Assessment of Dam Safety of Coal Combustion Surface Impoundments

Indianapolis Power & Light Company

Harding Street Generating Station

U. S. Environmental Protection Agency

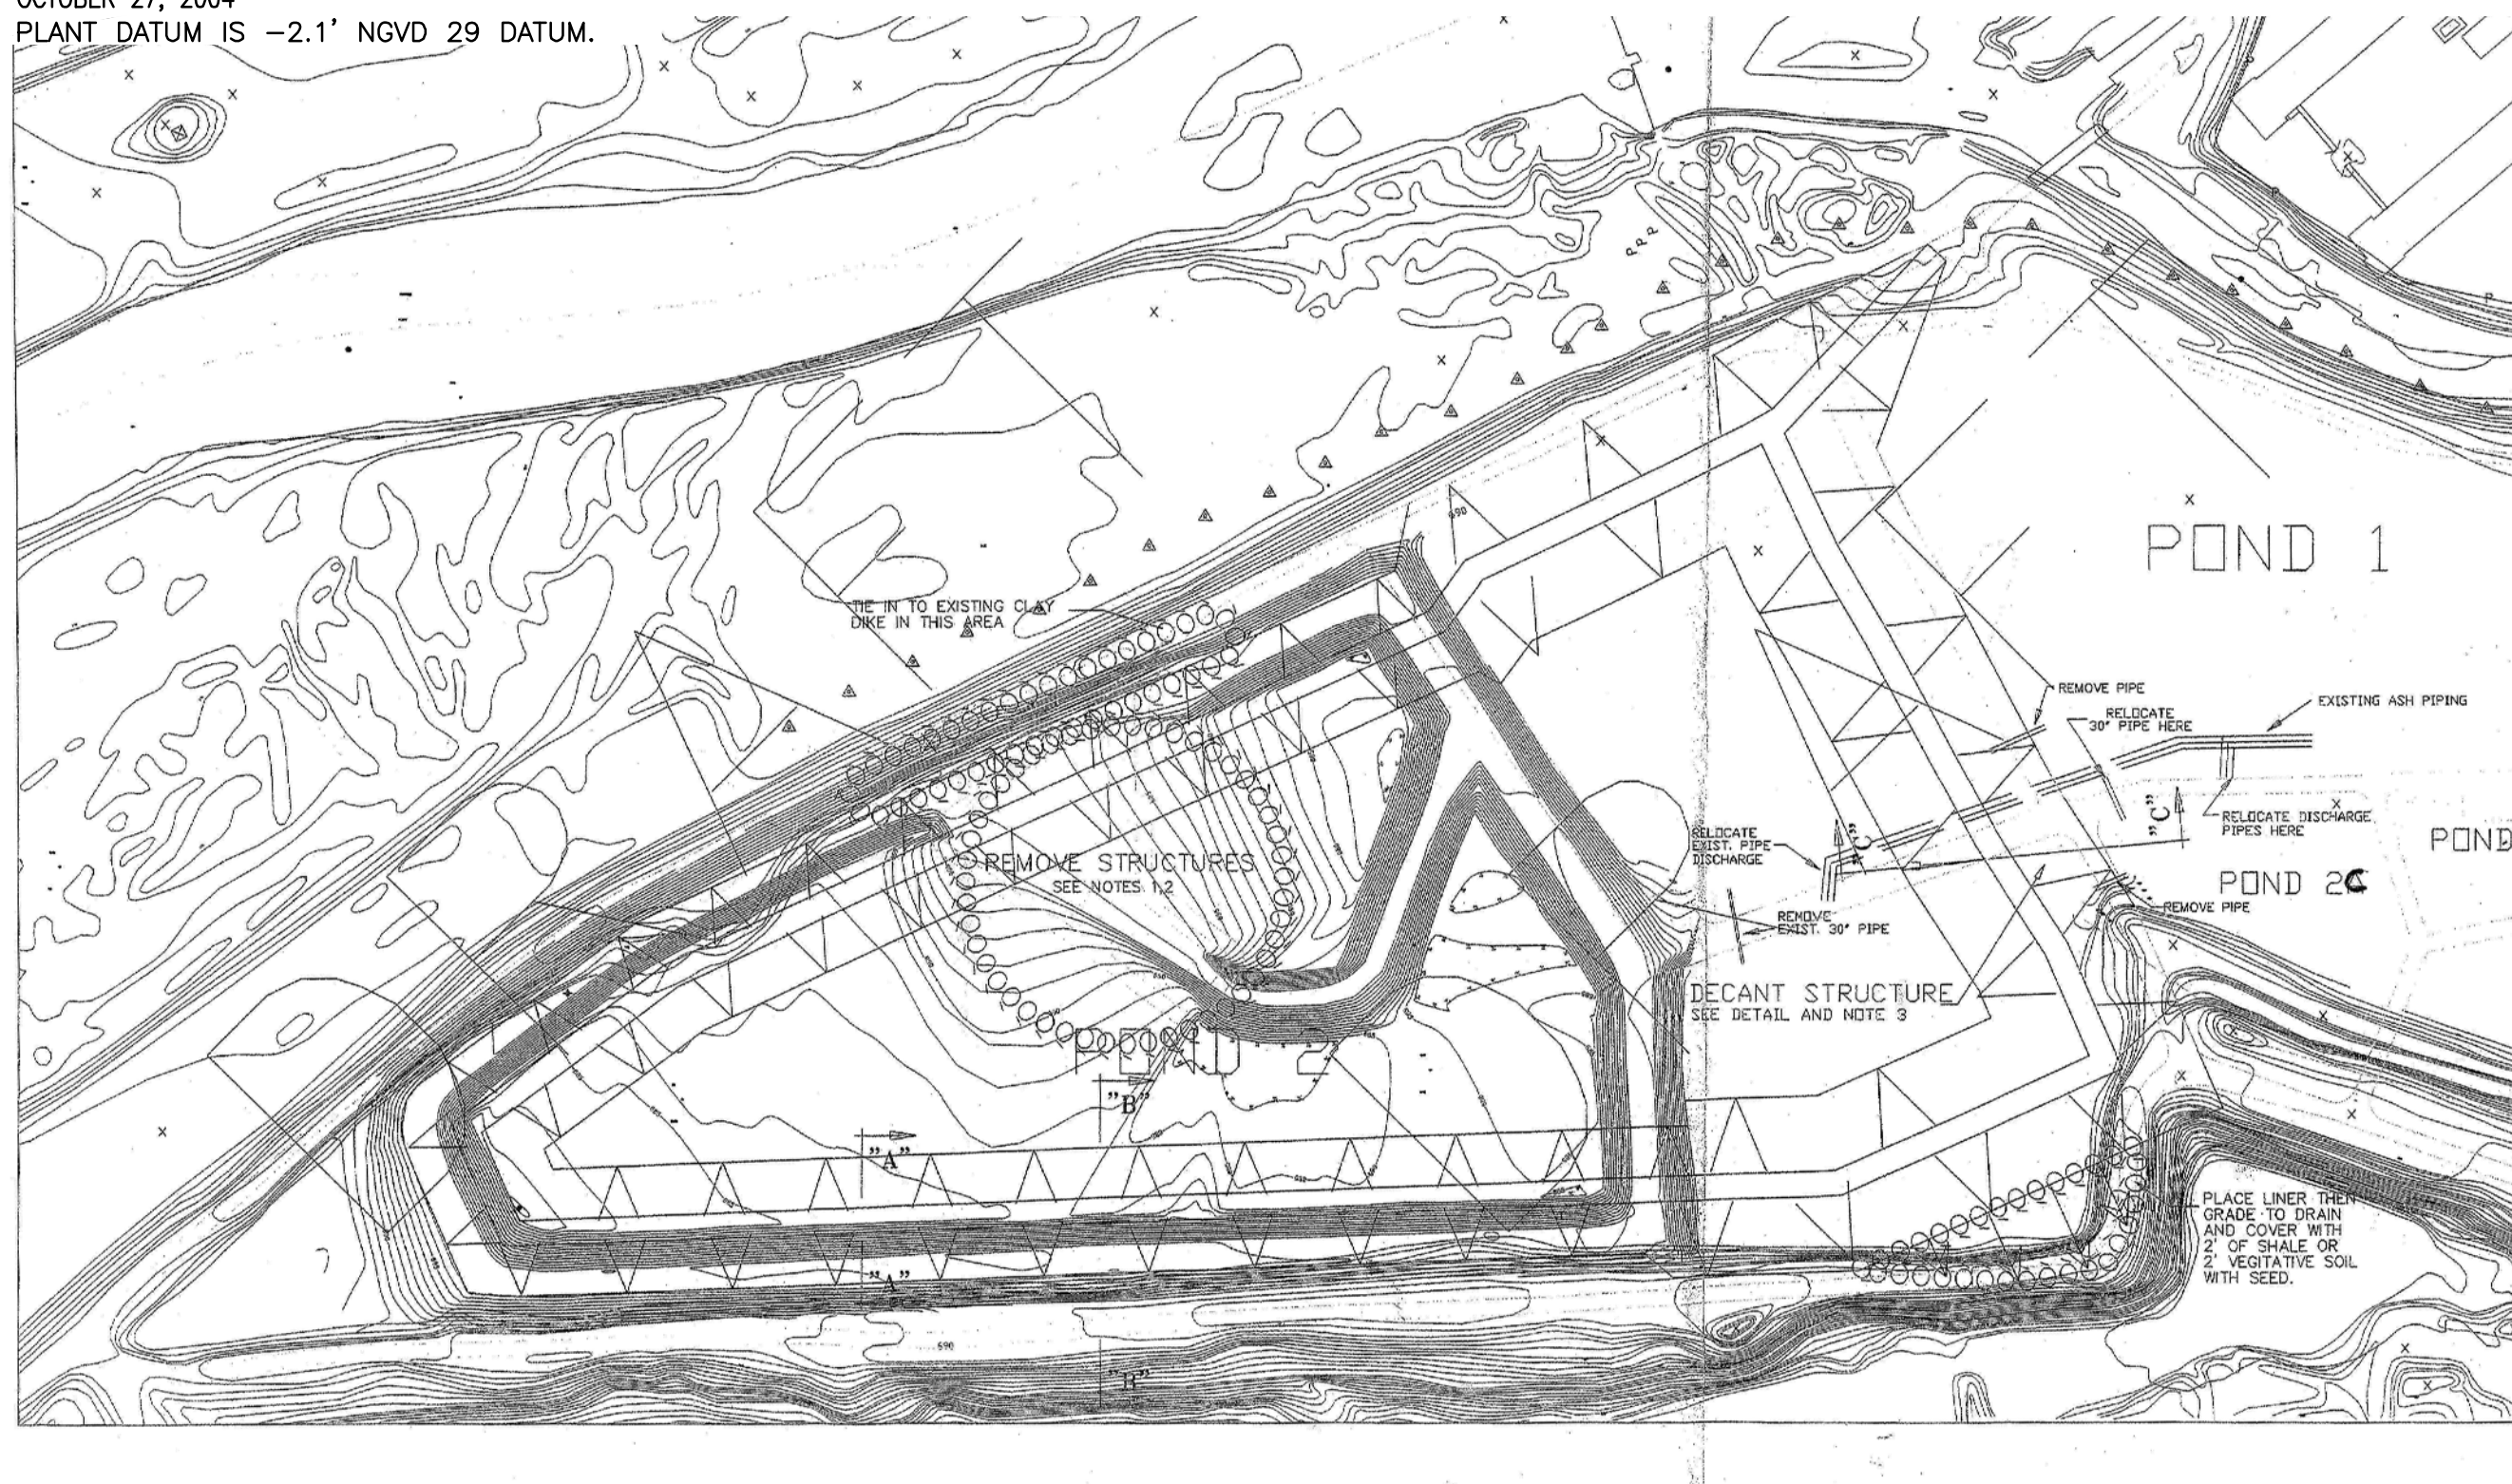
undisturbed soil at the base of the embankment, and then extends horizontally toward the toe of the exterior slope, as shown on [Figure 6](#), Section B-B. The information shown on Section B-B appears to indicate that the expanded embankment may have been constructed over hydraulically placed ash materials previously placed in the pond.

CDM was not provided with sufficient information to evaluate if the ash pond impoundments were constructed on wet ash, slag, or other unsuitable materials. Section B-B, Typical Levee Section, shown on the IPL drawing titled "Pond 2 Levee Improvement Ash Pond Area Plan", dated 10/27/04, indicates that the embankment of Ash Pond 2 may have been constructed over hydraulically placed ash materials. Based upon the available information, it is not possible to completely evaluate the nature of the foundation material underlying the Ash Pond 2 embankment.
